Request to Reconsider Howard Street One-Way Direction

South Depot Street → Appalachian Street

Submitted to: Boone Town Council
Submitted by: Ian Robinson
Date: 9/23/2026

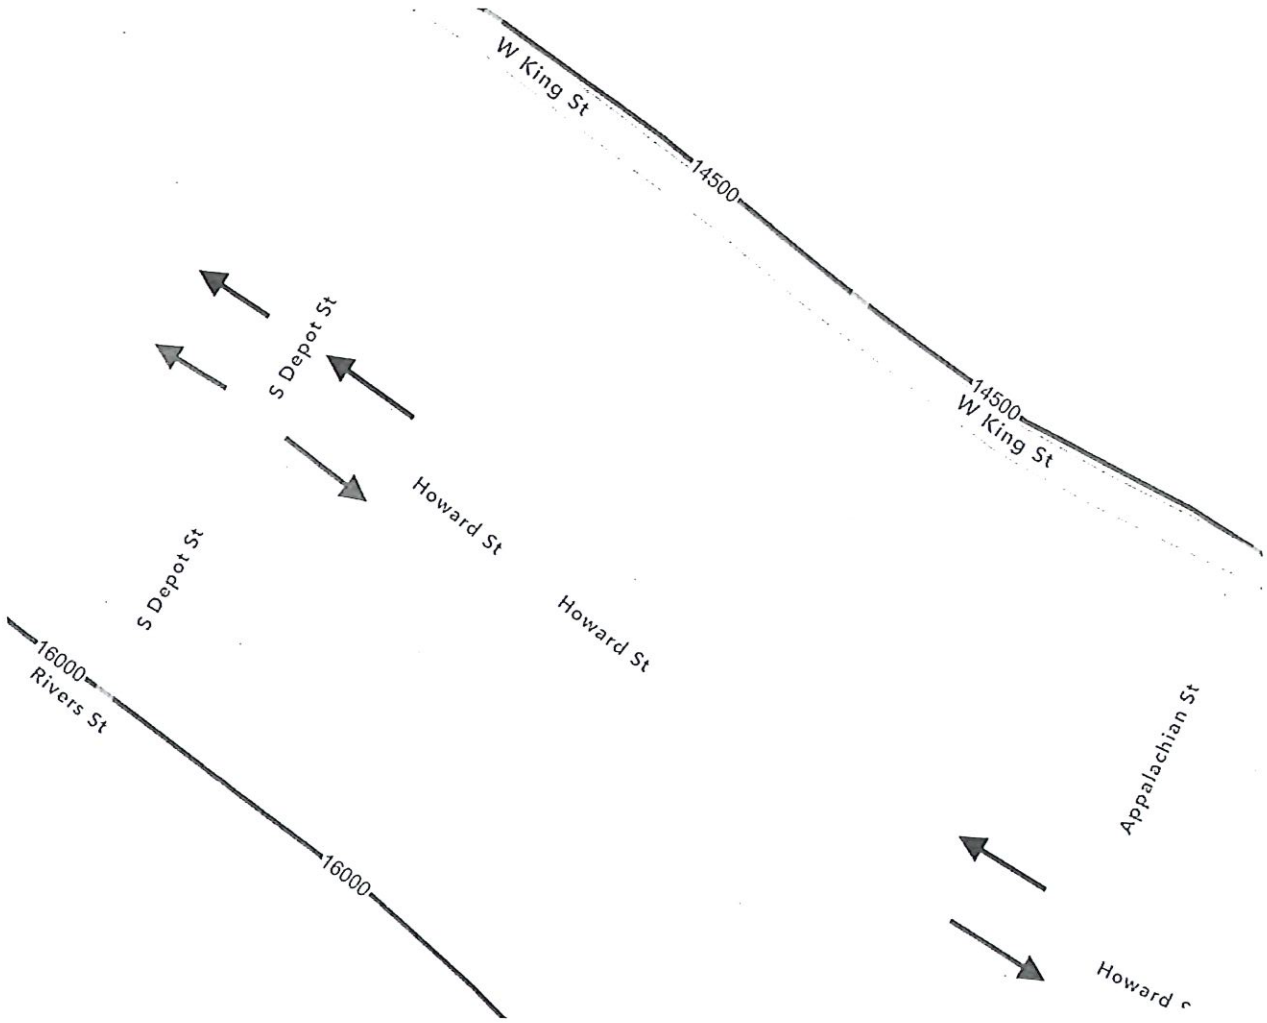
Requested Change:
I respectfully request that the Town of Boone reconsider the direction of one-way traffic on Howard Street between South Depot Street and Appalachian Street as part of the ongoing Howard Street Improvement Project.

Current direction:
Appalachian St. → Howard St. → S. Depot St.

Proposed direction:
S. Depot St. → Howard St. → Appalachian St.

This proposal would keep Howard Street one-way. It would simply reverse the direction of travel on this section. No change is being requested for the other sections of Howard Street.

3. The new parallel parking configuration supports reconsidering the direction
The Howard Street Improvement Project is substantially changing the street, including the addition of new parallel parking.
With the current direction of travel, the new parking is positioned on the left side of the travel lane. Reversing the direction would place the parking on the right side of the travel lane, creating a more conventional relationship between moving traffic and curbside parking/loading. This should be considered as part of the overall street design rather than treating traffic direction and parking configuration as separate issues.
